## **ZONING CHANGE REVIEW SHEET**

**CASE:** C814-2014-0120 – Austin Oaks Planned Unit Development

**Environmental Commission Date:** September 6, 2016

EXHIBIT C

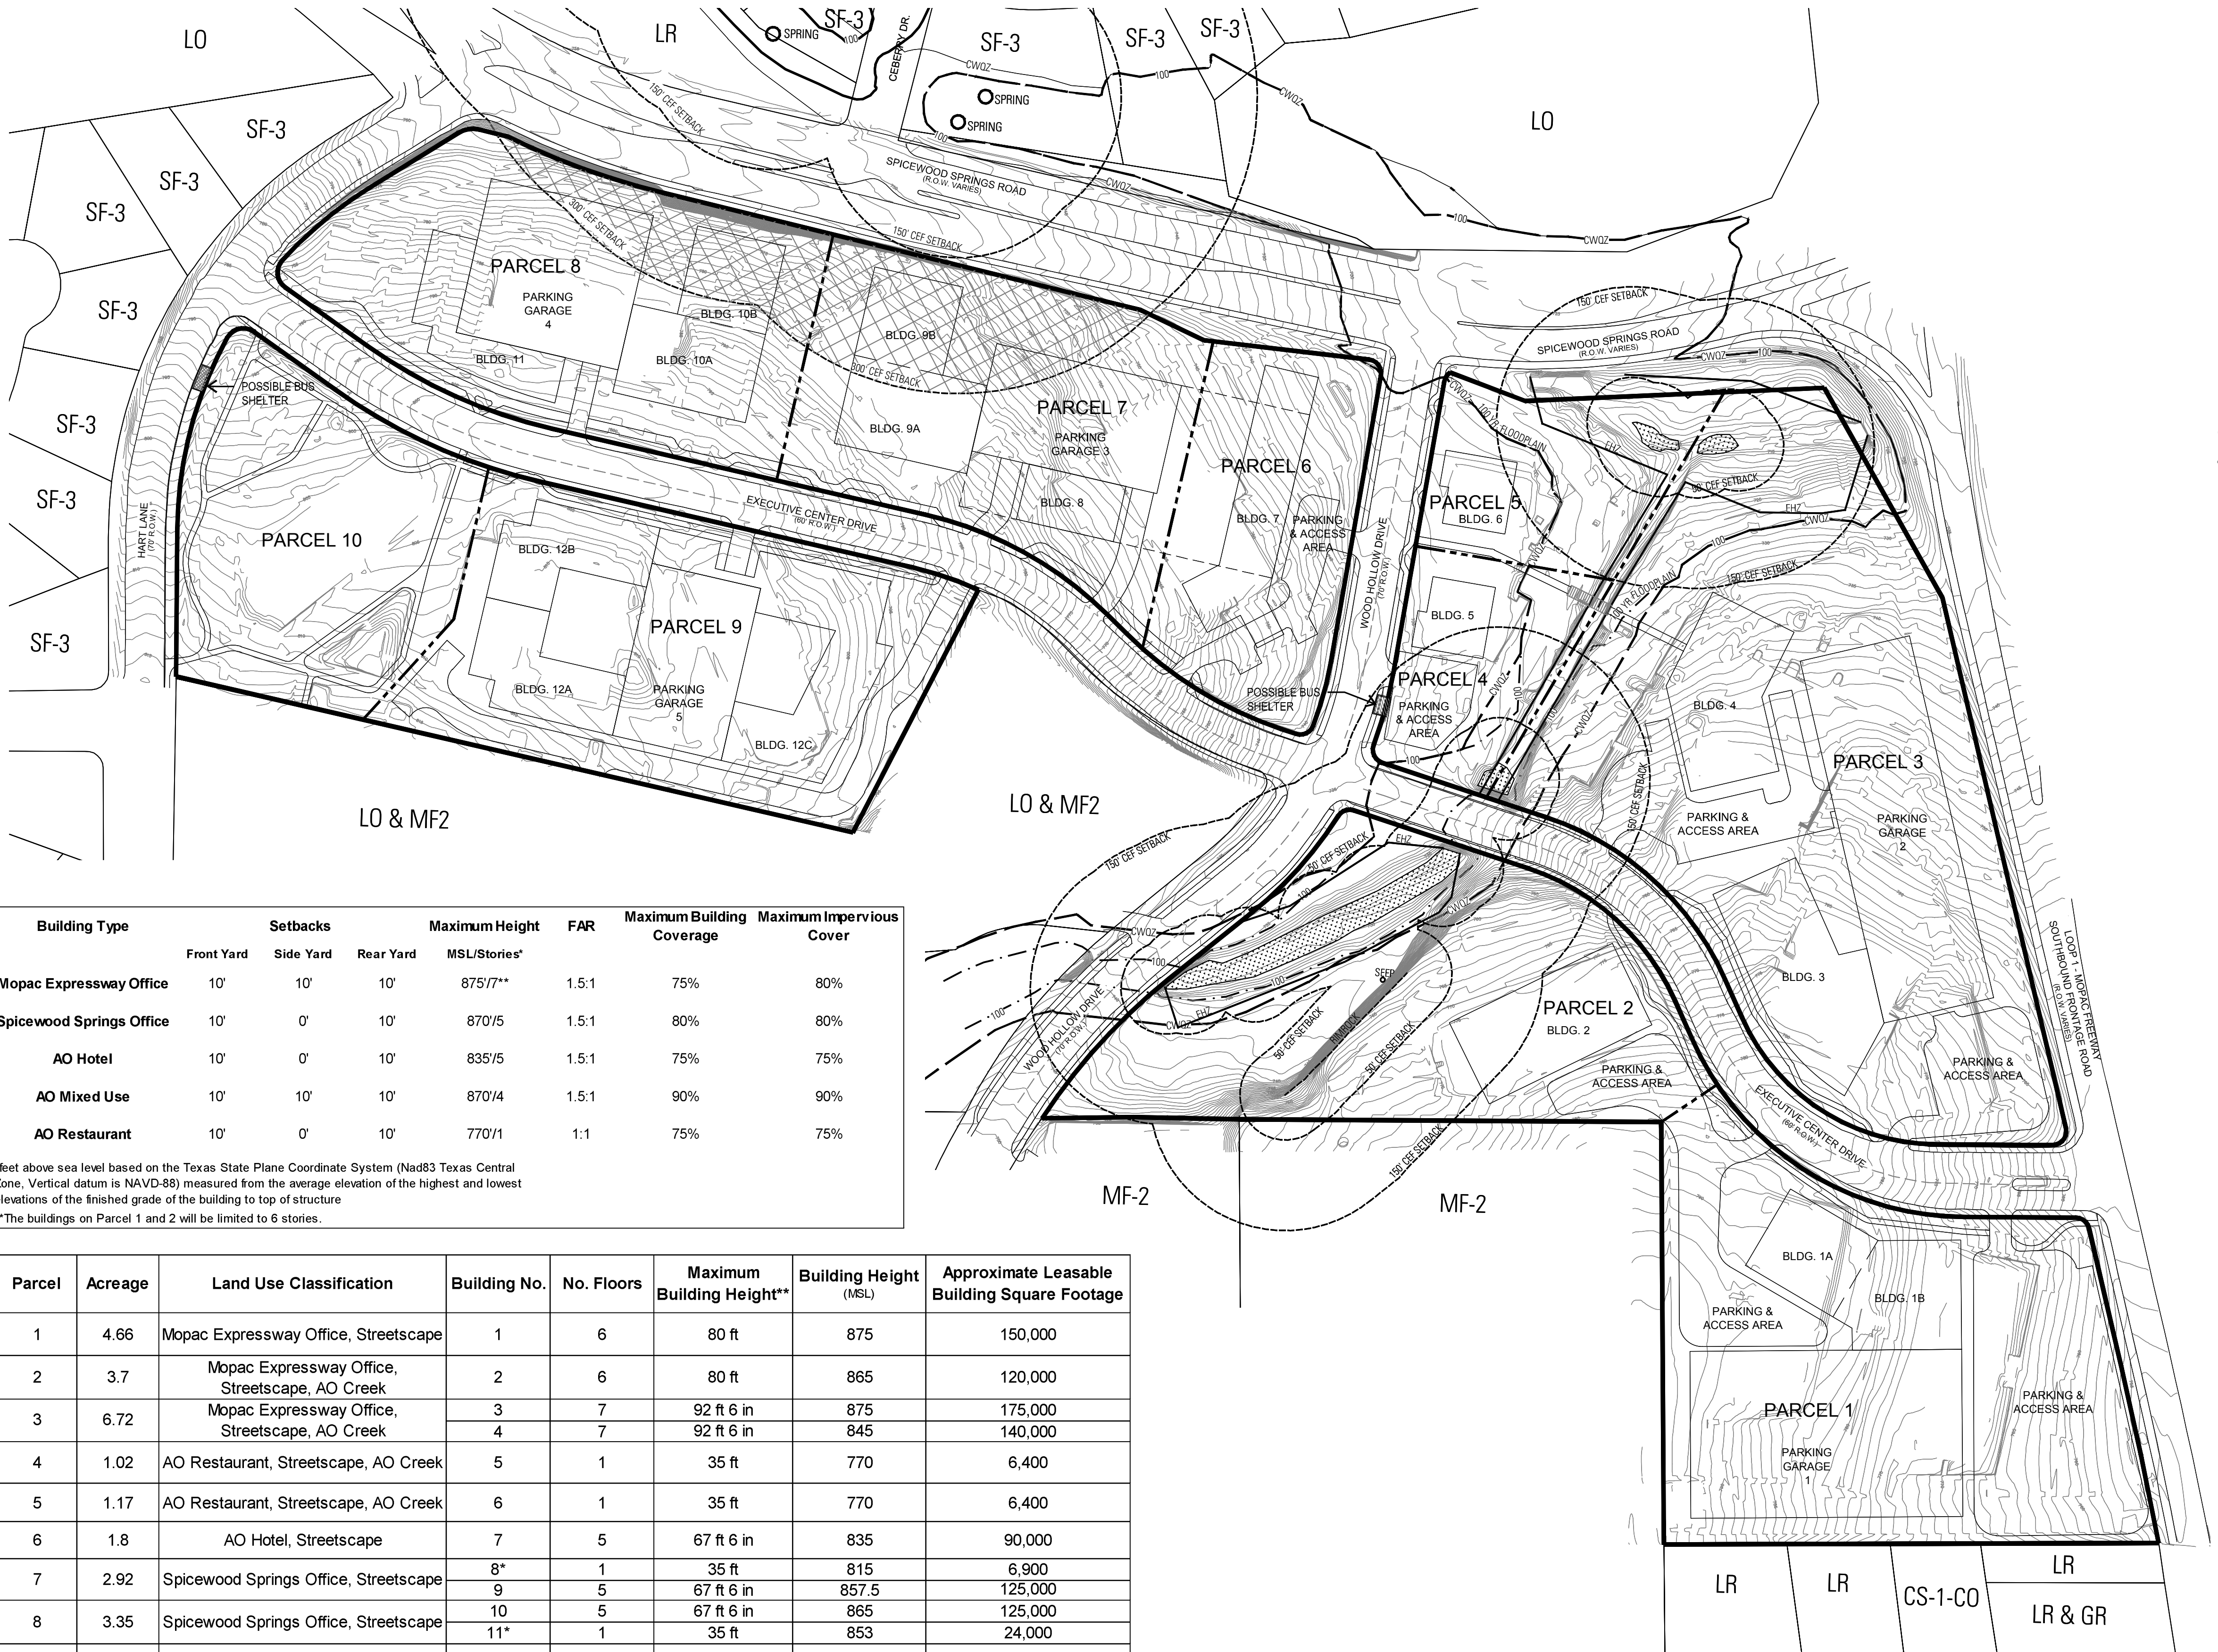
EO 15. The CWQZ, 100-year floodplain, and CEF buffers are difficult to read on this plan. Please revise the symbology to better illustrate the environmental features on the land use plan. Can the Erosion Hazard Zone and Drainage Easements be removed to make the plan easier to read?

Update 4: Under 25-8-92(F), the boundaries of a CWQZ in an urban watershed coincide with the boundaries of the 100-year fully developed floodplain, with a minimum width of 50' and a maximum width of 400'. There are several places where the 100-year fully developed floodplain extends beyond the identified CWQZ. Please correct the CWQZ boundaries to follow the 100-year fully developed floodplain in areas where the floodplain width is between 50' and 400' from the creek centerline. (Maintain a minimum CWQZ width of 50' where the floodplain is narrower than 50' from centerline.)

### STREAM LAYING BACK SECTION

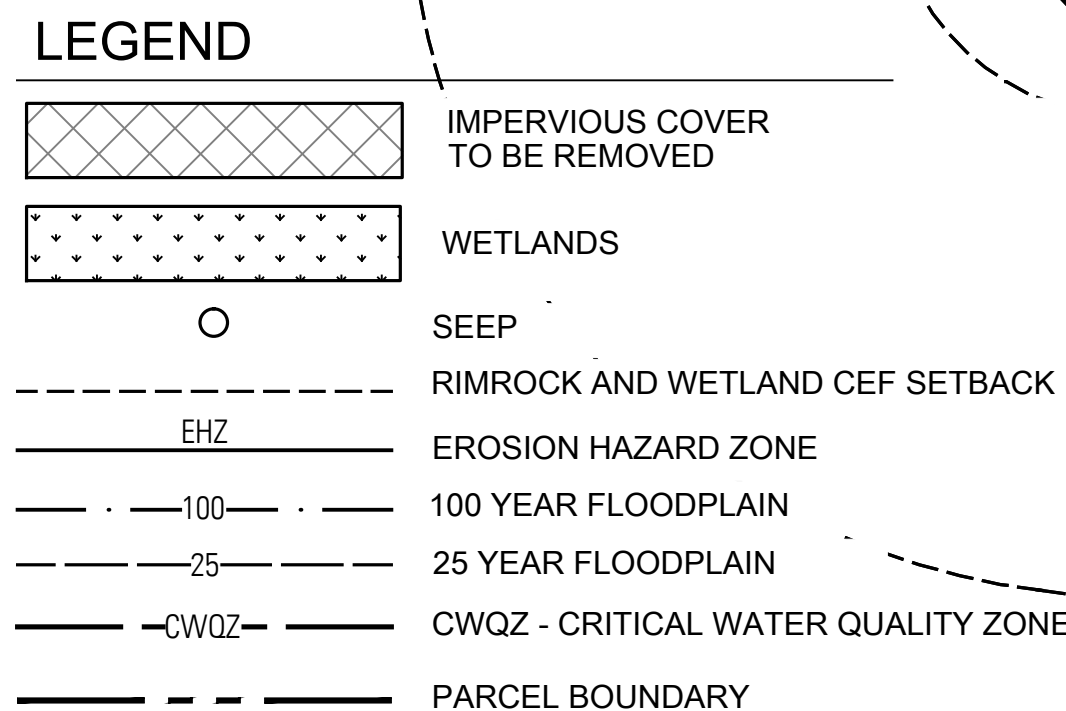
As discussed during recent meetings with staff and the Environmental Officer, please update the table to include the commitment to laying back and restoring the western creek bank. Include a drawing showing a conceptual cross section, the area of bank to be laid back, how the pedestrian bridge is to be incorporated, revegetation requirements, etc., as well as text in the Tier 2 table describing the plan with estimated detention volume. Also, include text describing alternative plans in case of subsurface geology preventing maximum lay back area.

EXHIBIT H

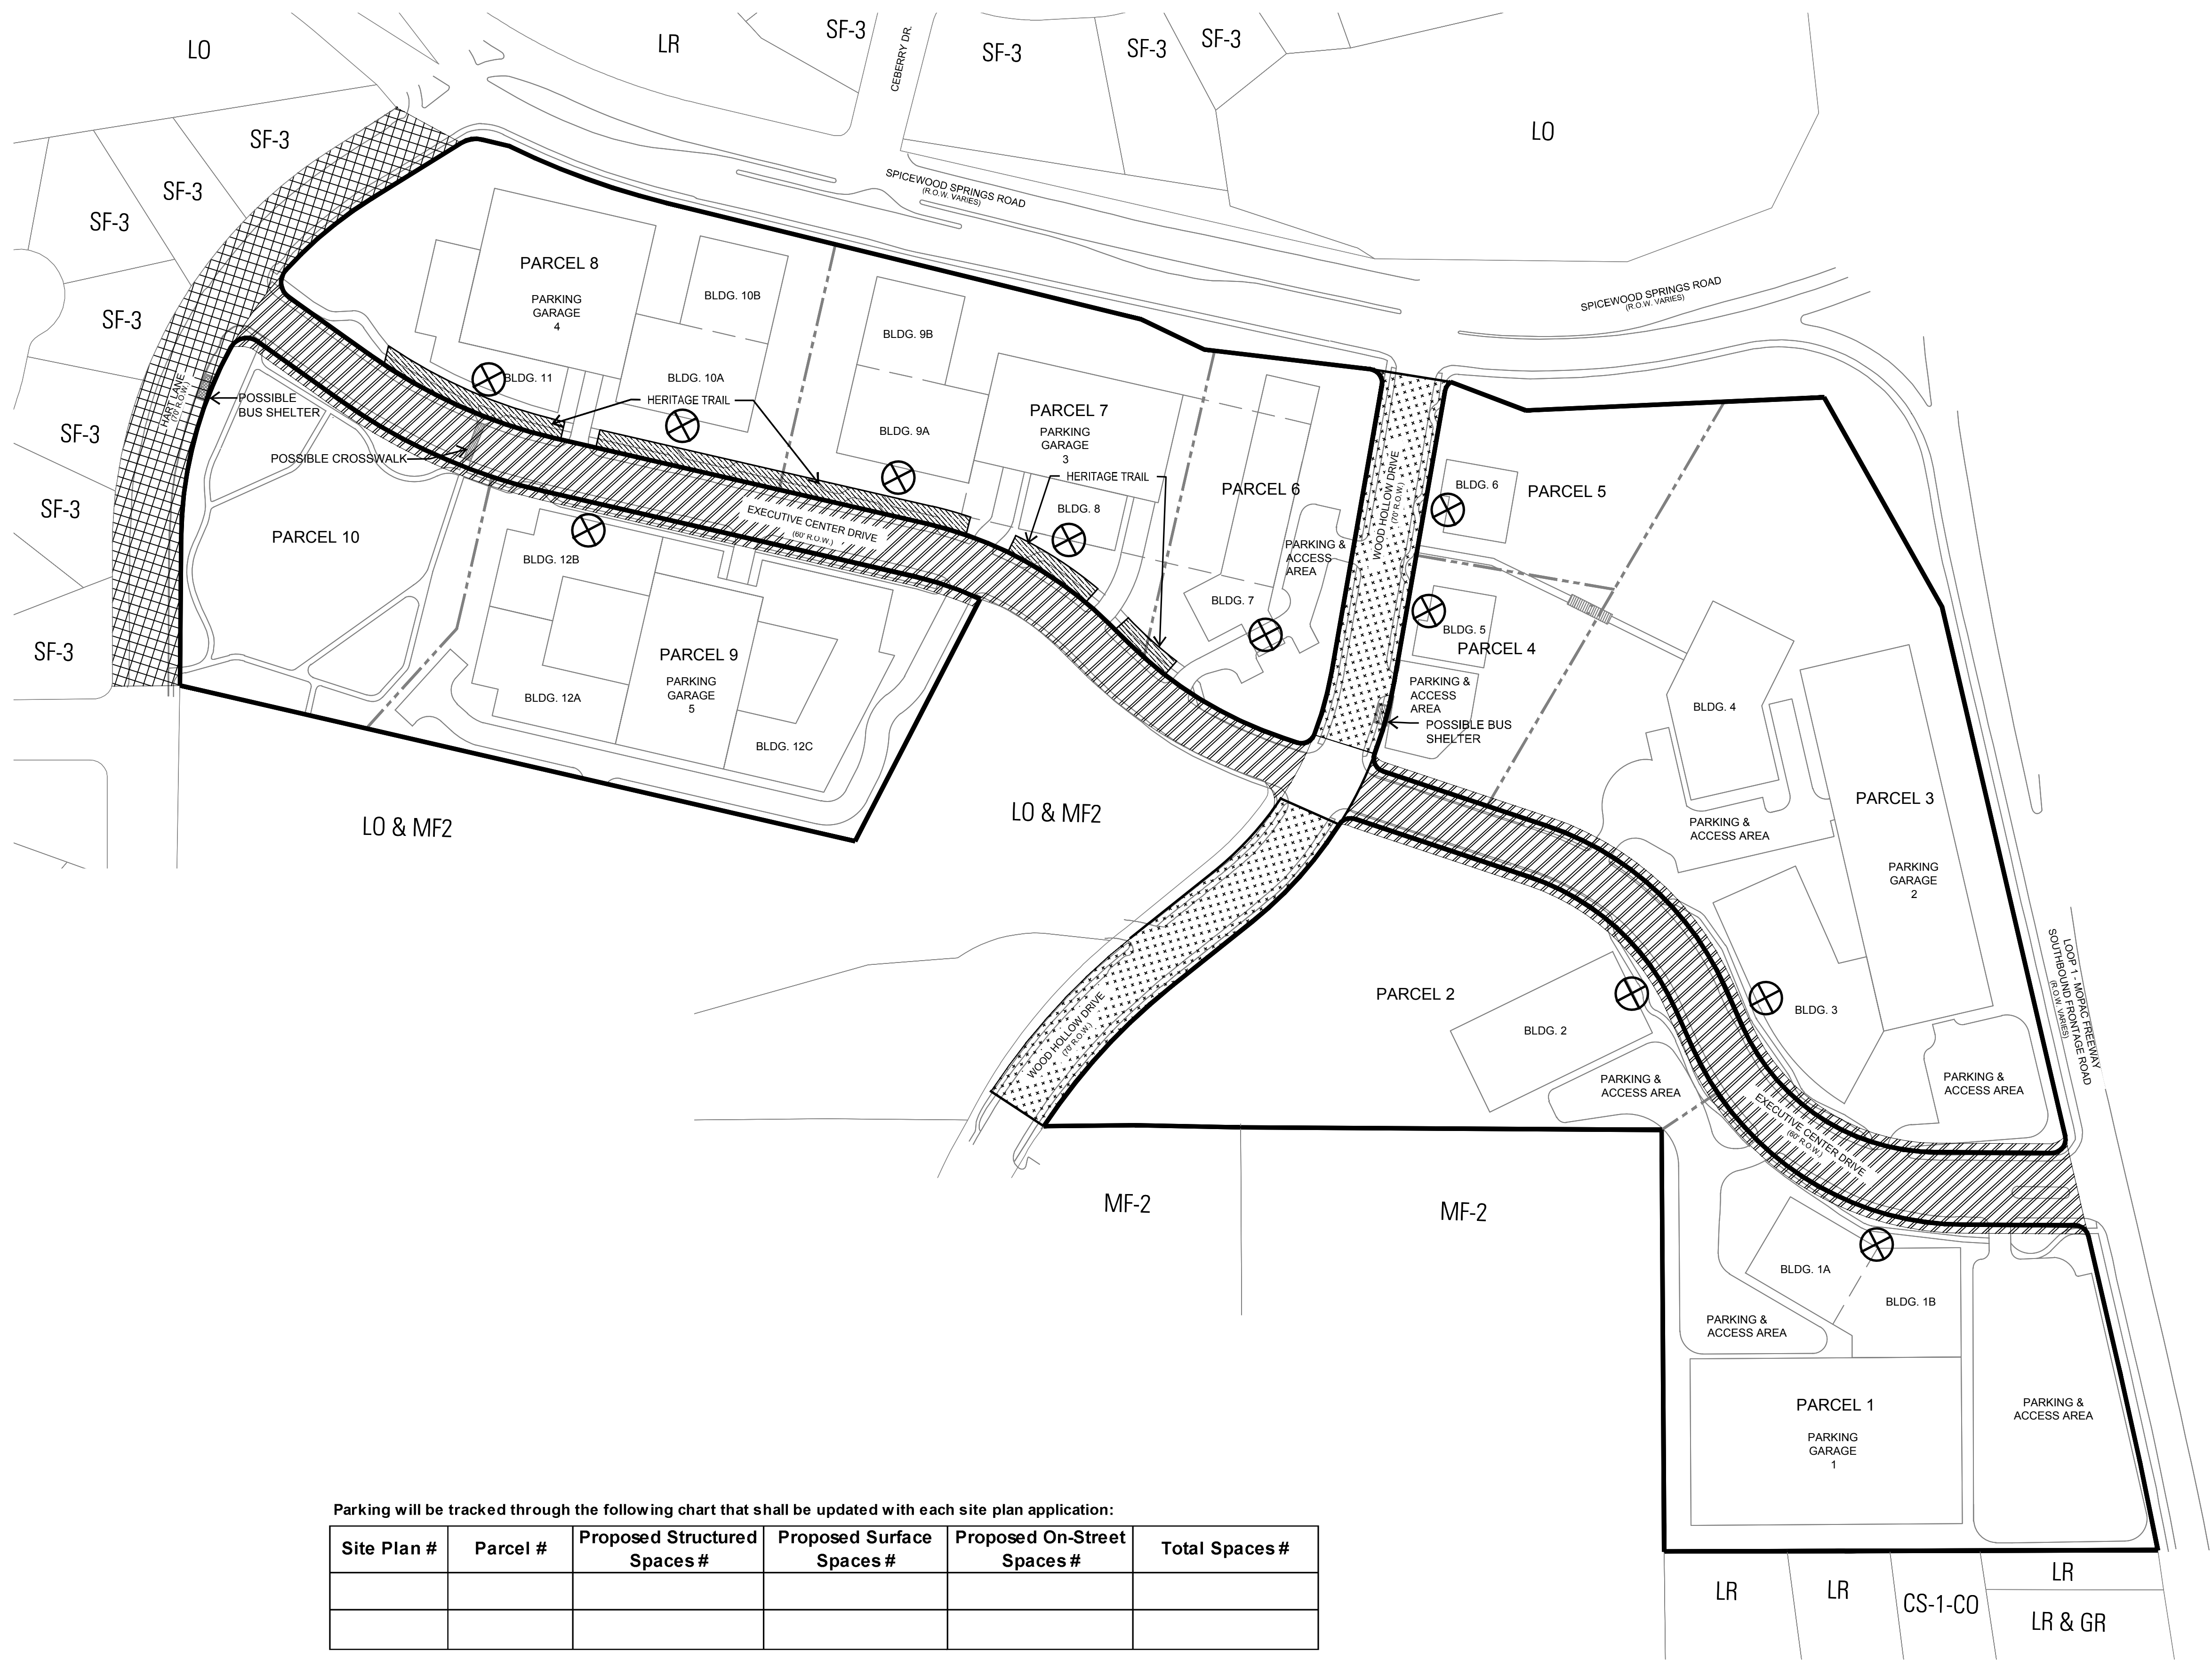
EO 17. As noted in EO [15], the boundaries on this exhibit are difficult to read. Please revise the symbology to better illustrate the environmental features and restoration areas, and remove any information that is not necessary for PUD review (e.g., EHZ, drainage easements, etc.).

Update 4: There are several places where the 100-year fully developed floodplain extends beyond the identified CWQZ. Please correct the CWQZ boundaries to follow the 100-year fully developed floodplain in areas where the floodplain width is between 50' and 400' from the creek centerline. (Maintain a minimum CWQZ width of 50' where the floodplain is narrower than 50' from centerline.)

EO 18. Please delete notes 1, 2, and 5, and delete or revise notes 3, 4, and 6 to reflect requested changes to the superiority table. All significant elements of the PUD proposal should be included in either the superiority table or a code modification table. Notes on the exhibit can repeat,

reference, or add details to those proposals, but the exhibit notes should not be the only source of this information.

Update 4: Update the restoration language in Note 2 to match the staff suggestion above. Please add a note specifying that the proposed pedestrian bridge must span the erosion hazard zone with one set of piers within the creek channel if necessary.

Note 2 and the restoration language suggested above only apply to areas within the CWQZ and CEF buffer. There are some areas where impervious cover will be removed that are outside of the CWQZ and CEF buffer. Staff suggests specifying that areas outside of the CWQZ and CEF buffer will be planted and seeded pursuant to Standard Specification 609S, but that those areas do not need to achieve a score of “Good” under the floodplain modification parameters.

- FYI, Please address the informal comment from Andrew Clamann, Wetlands Biologist, regarding the terminology used in Note 5 of Exhibit H regarding encountering bedrock in the “Stream Laying Back Area.” The current definition includes unlithified earth material such as soil, alluvium and rock fragments but should refer to lithified, consolidated bedrock.
